# NORTH BRANCH

**PLANNING COMMISSION  
SPECIAL AGENDA  
MONDAY, SEPTEMBER 16, 2024 @ 6:30 PM  
CITY HALL, 6408 ELM STREET, NORTH  
BRANCH, MN 55056**

**Subject: Public Hearing for Preserve at Spring Hill 2nd Addition**

# CONSTRUCTION PLAN FOR PRESERVE AT SPRING HILL 2ND ADDITION

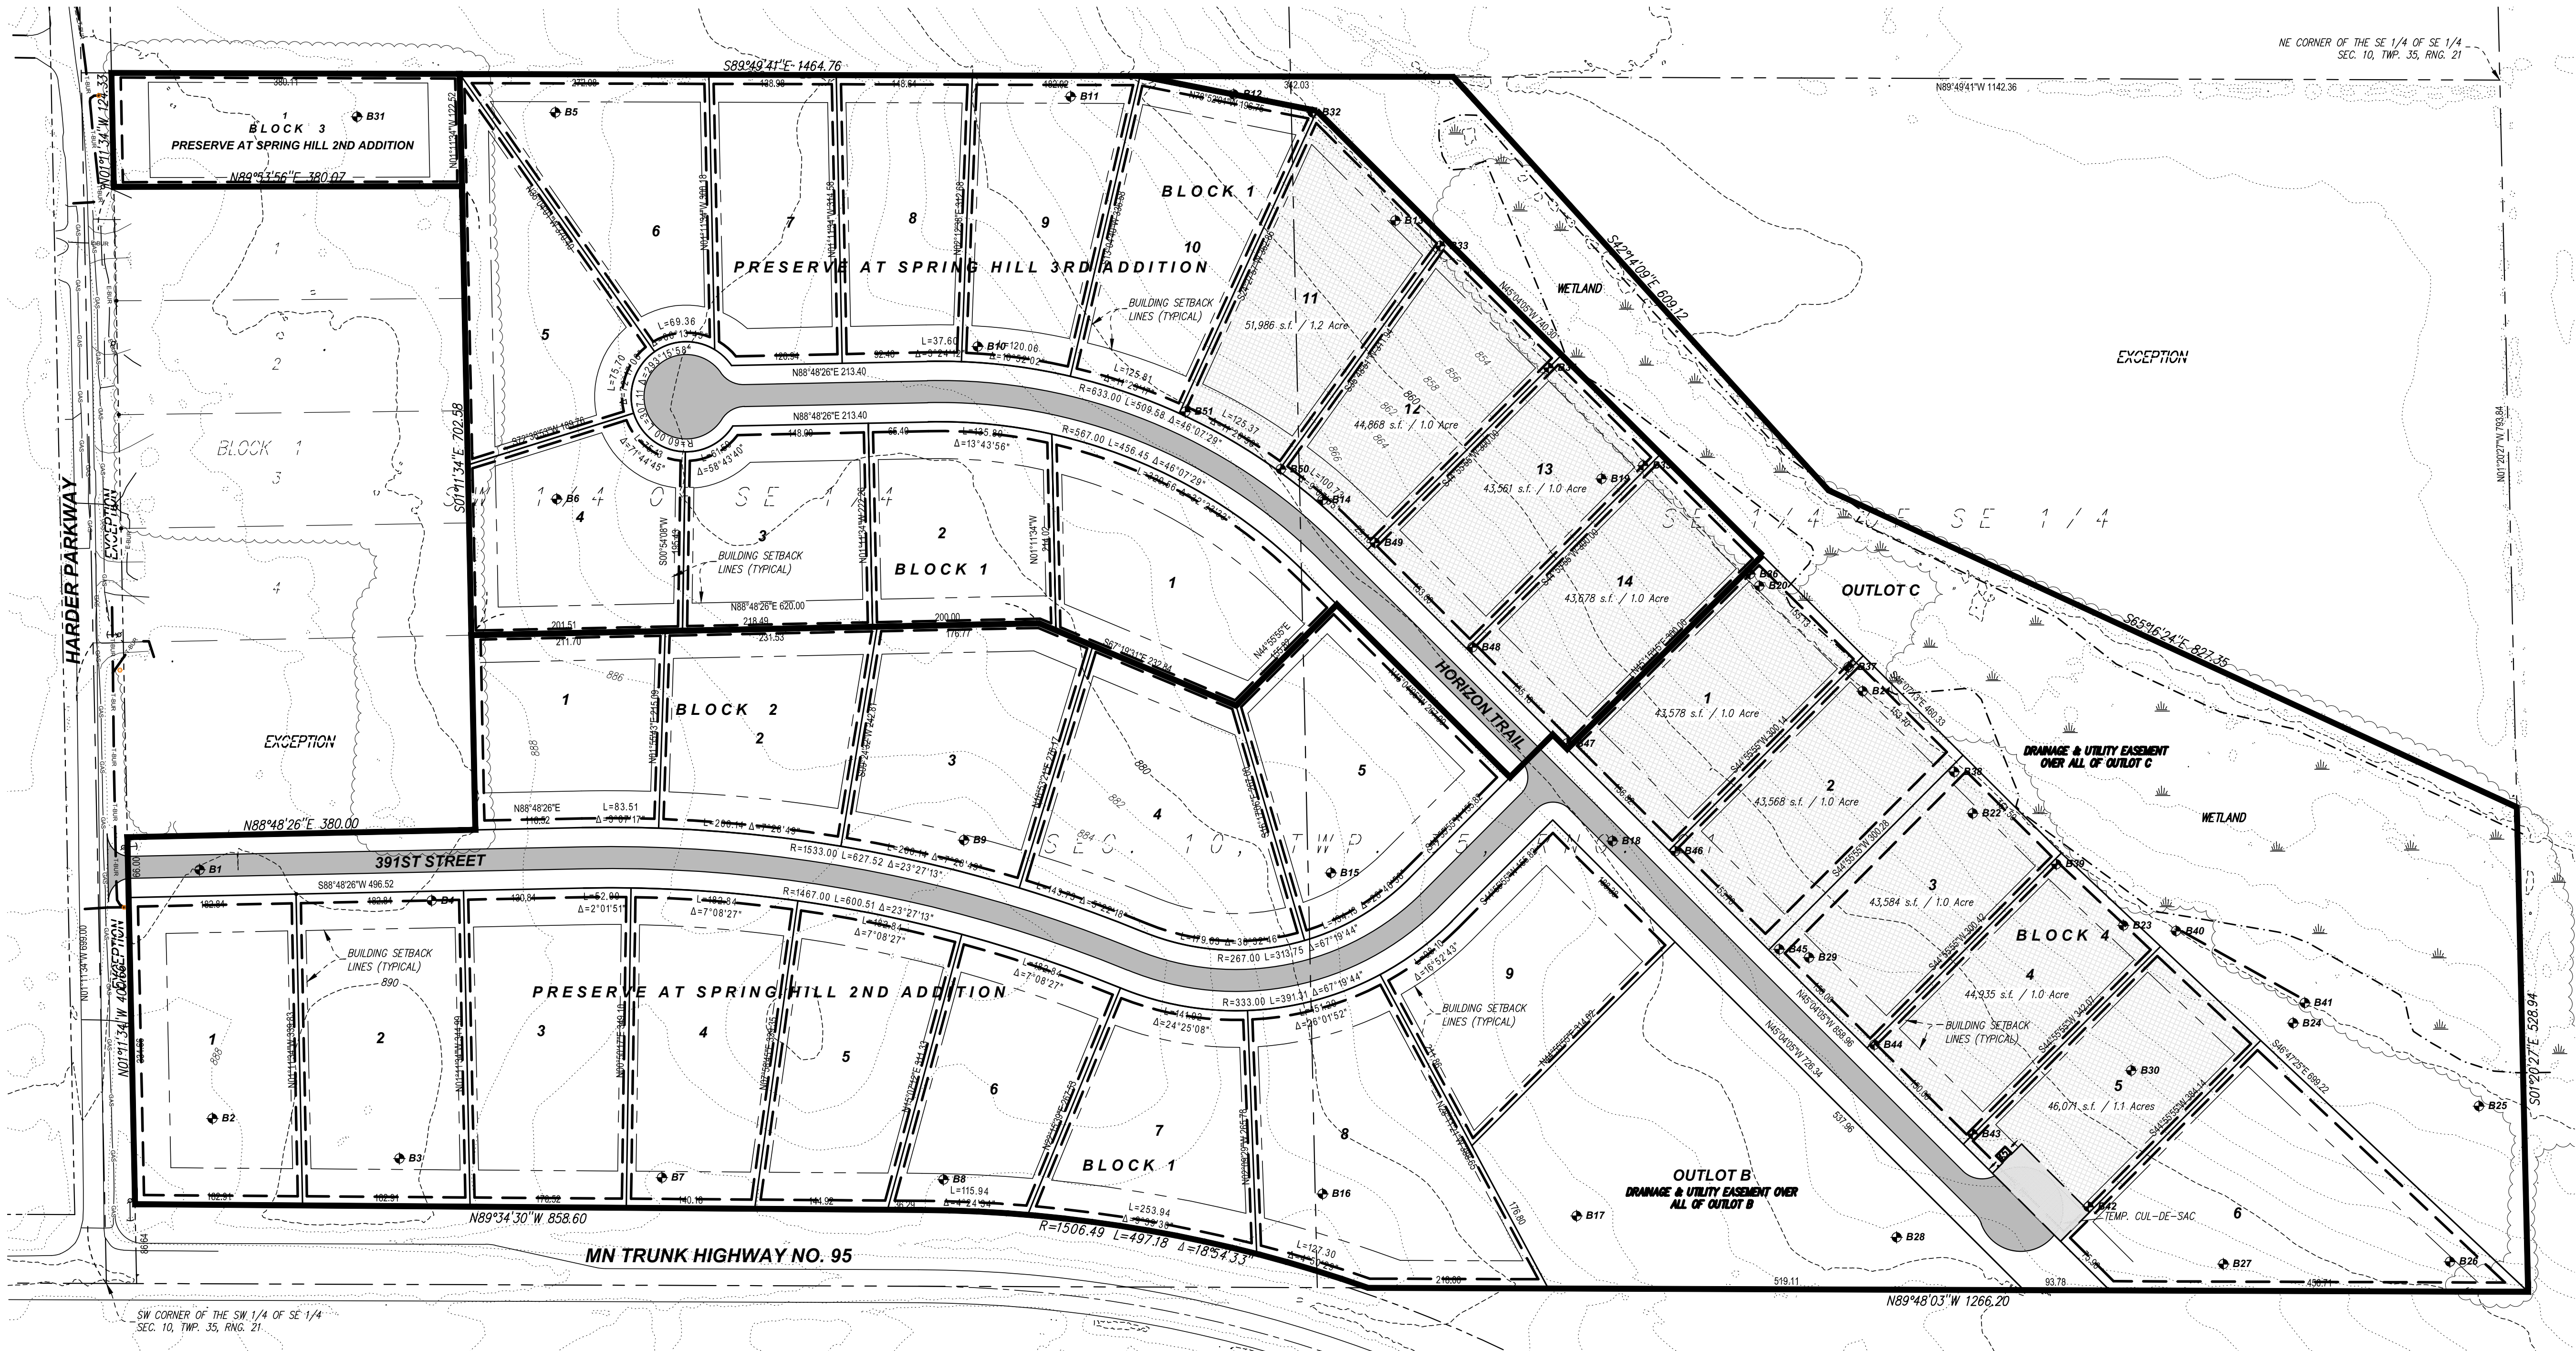
The tree preservation plan shows that 4% of the 281,267 sq ft of trees will be removed. It appears that an additional approximately 2,800 sq ft of trees will be removed at the entrance of the development that is not shown on the preservation plan. This additional removal would bring the total percentage of trees to be removed up to approximately 6.4%, which is well under the 50% permitted to be removed by City Code.

The Applicant has not submitted a landscaping plan to date. Per Section 66-974, the Applicant is required to plant a minimum of one tree per dwelling unit with a mixture of deciduous and coniferous trees. Staff is recommending a landscape plan to be submitted meeting these requirements as a condition of approval.

*Updated tree preservation plan and landscaping plan is requested as a condition of approval.*

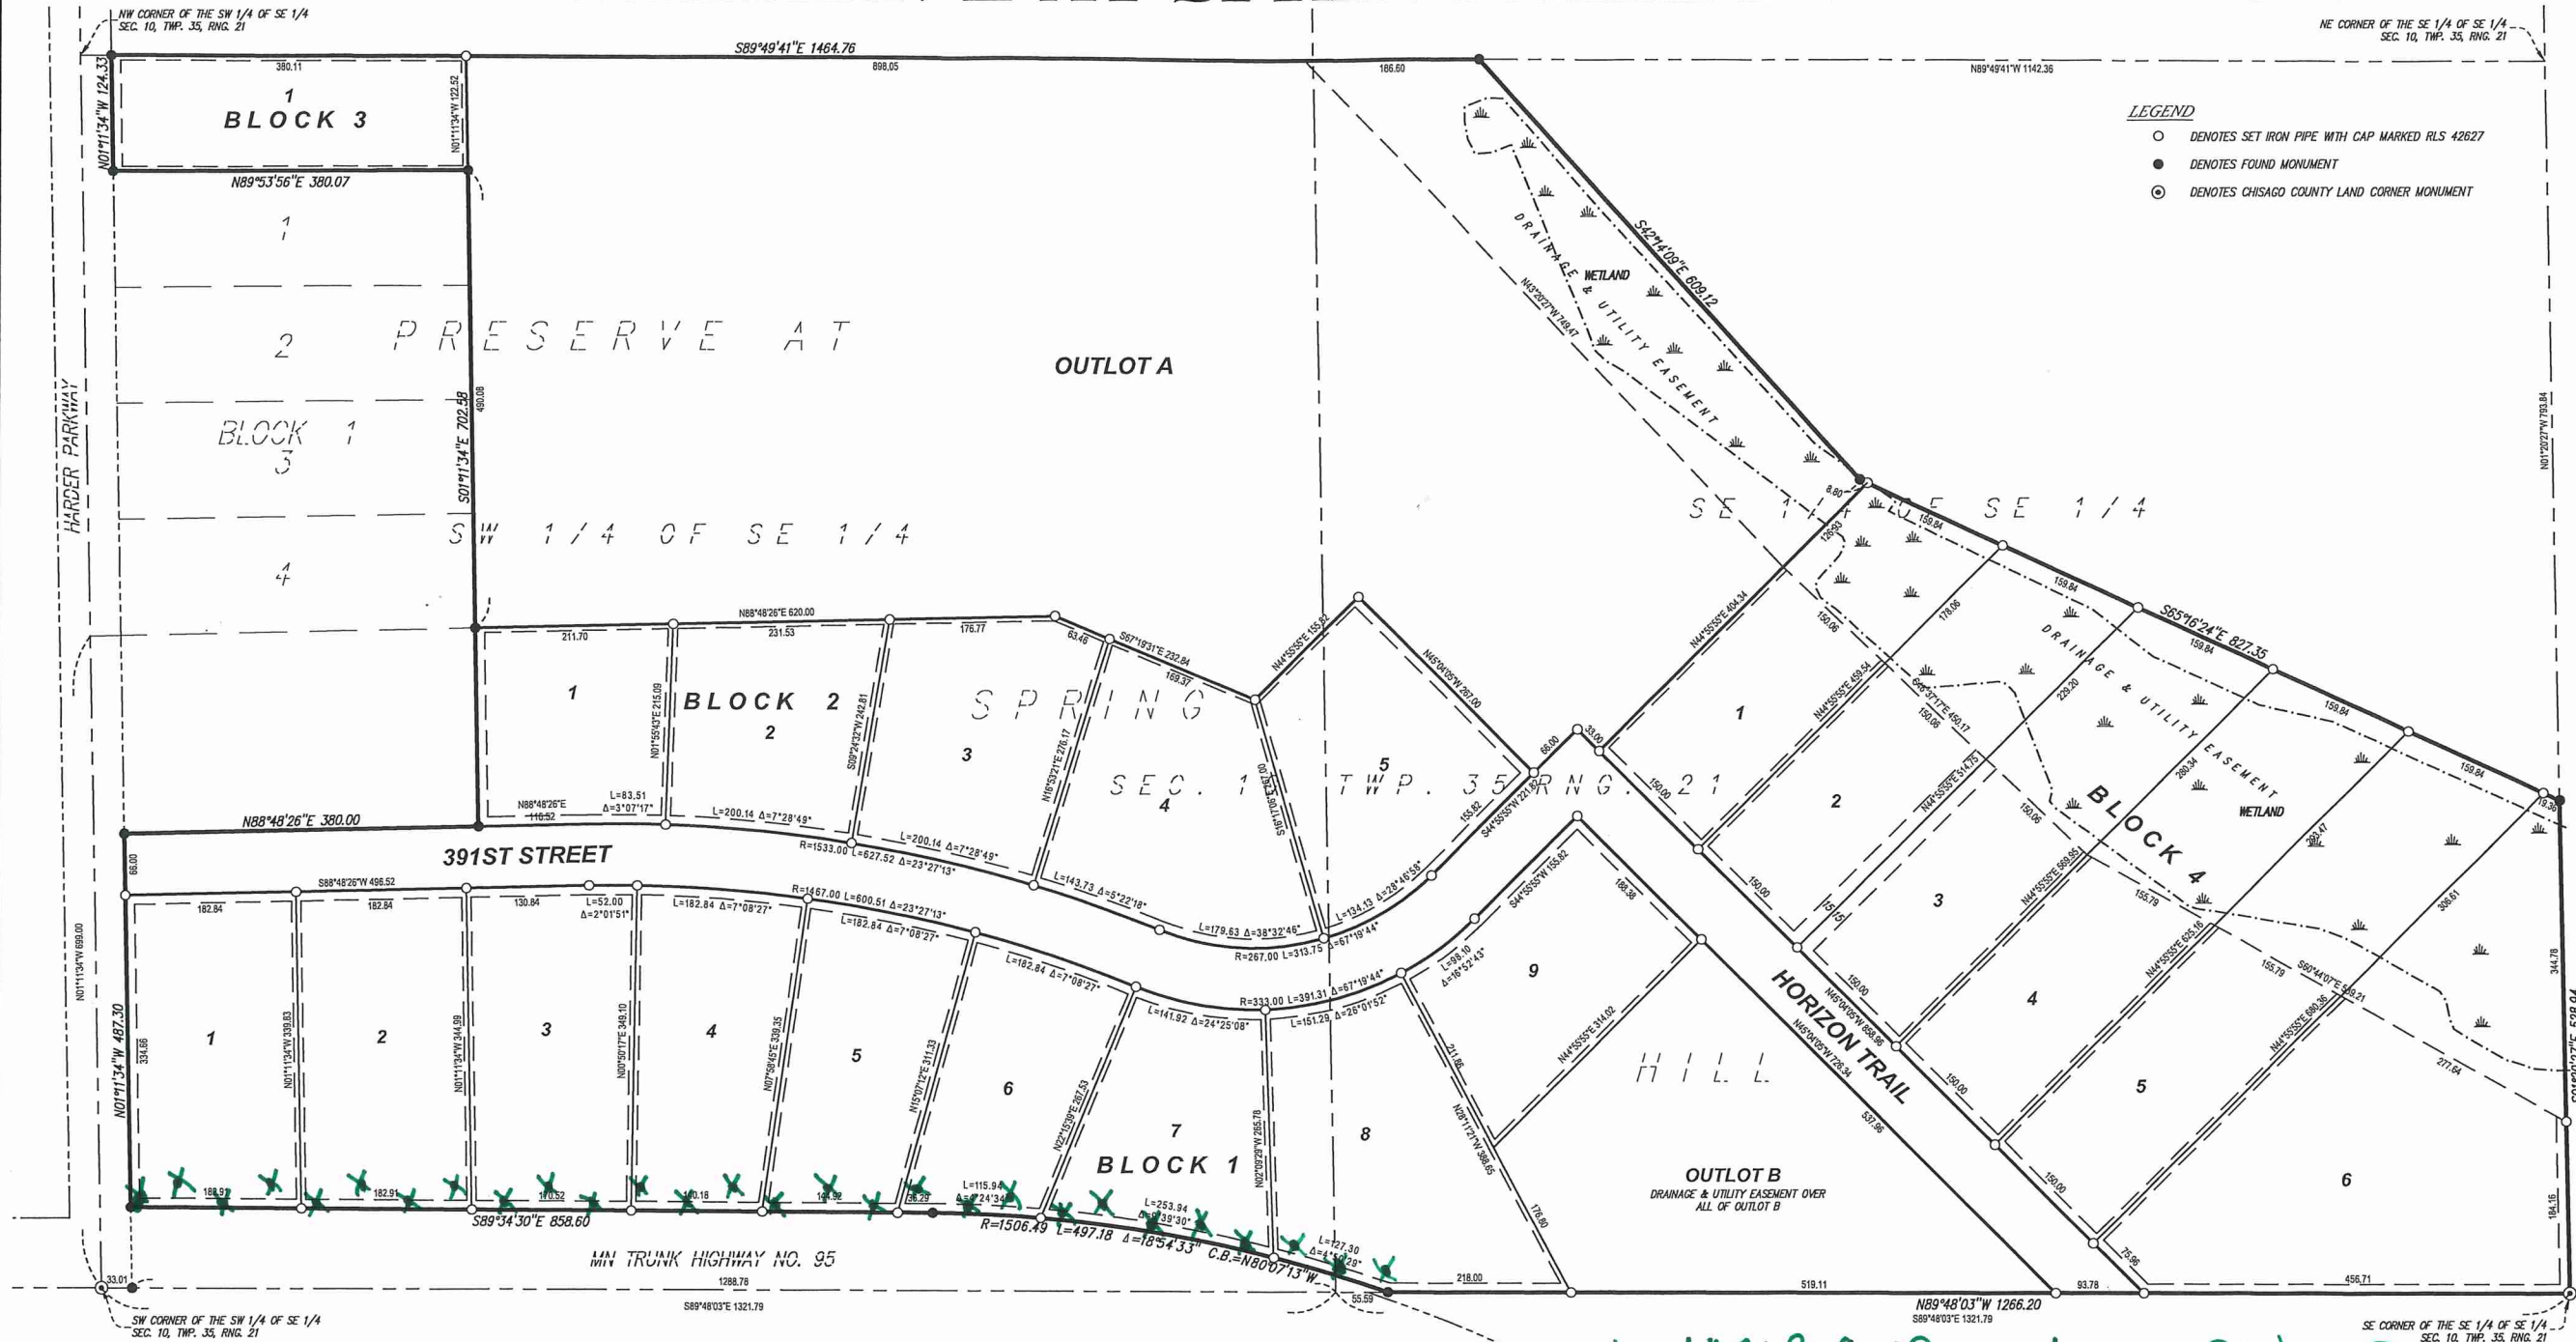
- Full engineering comments on the plans dated October 1, 2021 are forthcoming.
- Update the plans to show the retention basins will be covered with a fiber erosion control blanket to aid with future vegetation in the basins. Installation shall meet the specifications in the City Standard Detail Plate ERO-006 attached.
